**Response to the Utility Regulator's
GD23 Draft Determination
May 2022**

Figure 31 – Maintenance activity required during the GD23 period

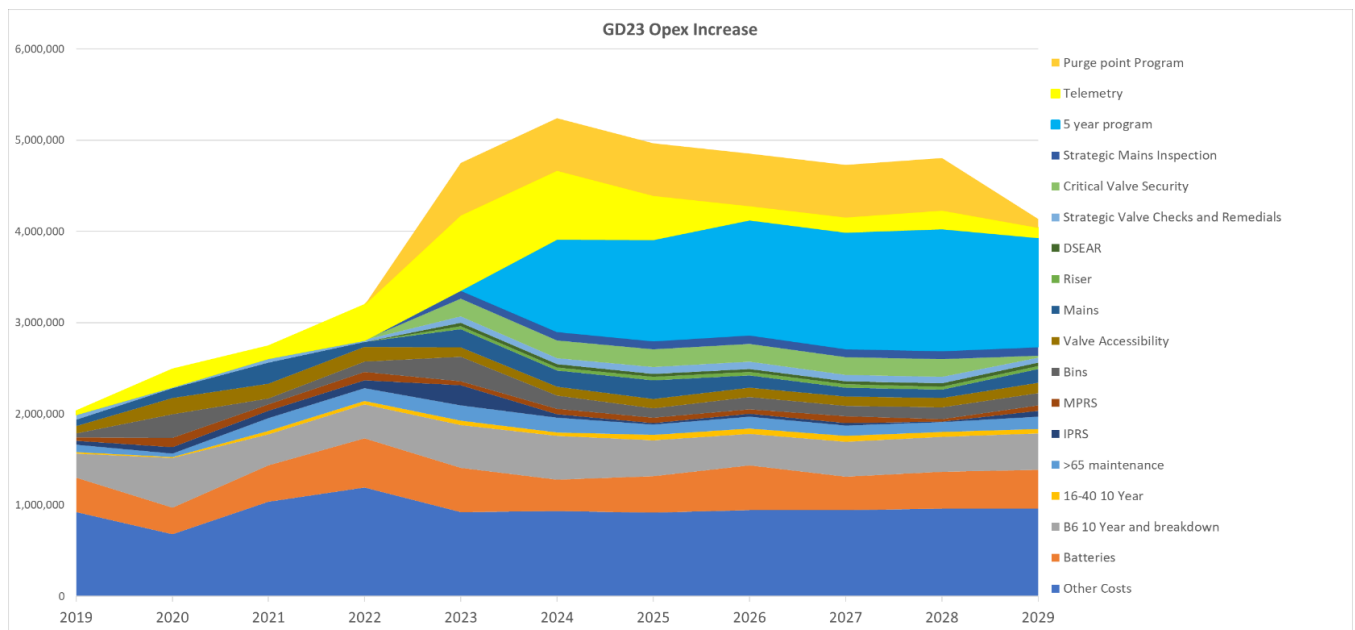
PNGL has requested only a small increase in FTEs in the GD23 period to support this significant increase in maintenance activity. Table 32 provides information on the actual FTEs employed to support maintenance activities in 2019 and 2020, those required to support the significantly higher levels of maintenance activities to be performed during the GD23 price control period and the FTEs proposed by UR for the GD23 period.

Table 34 – Comparison of emergency call volumes received by PNGL on a monthly basis in 2020 versus 2017-2019

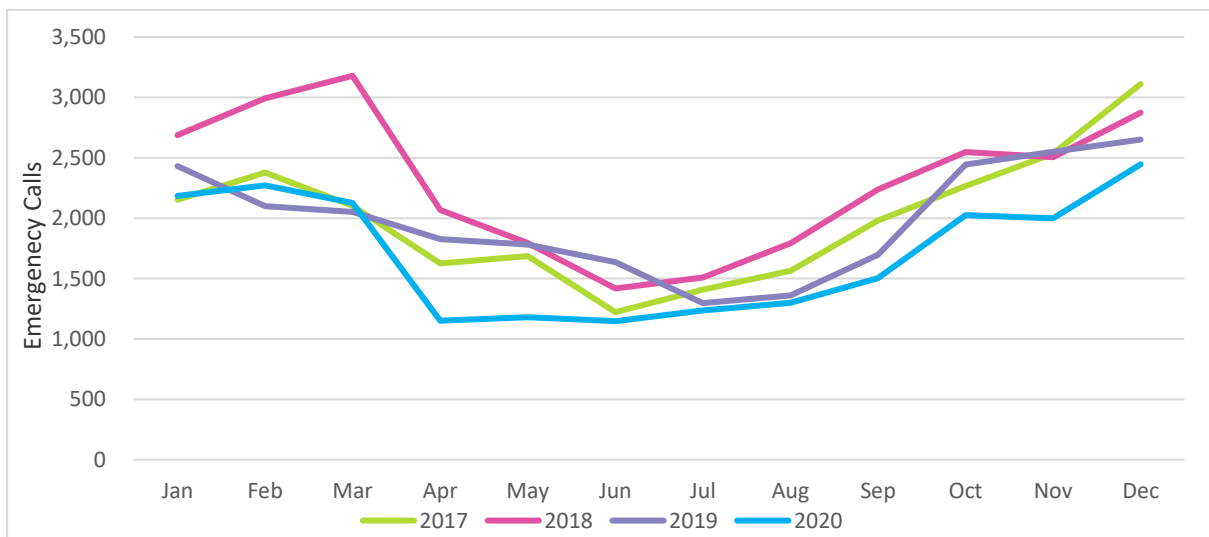
2020 was an abnormal year. Similar to other UK GDNs, PNGL experienced a 35% drop in emergency calls in Q2 2020 that was directly attributable to the pandemic and the reluctance of customers having utility personnel visit their homes. Table 34 provides an overview of the emergency call numbers PNGL experienced in 2020 compared with the first half of the GD17 period:

When developing its estimate for the volume of emergency calls during the GD23 period, PNGL also utilised historic call volumes from the GD17 period but elected to exclude 2020 from its analysis, given the impact of abnormal customer behaviour experienced during the pandemic that would not be reflective of the GD23 period.
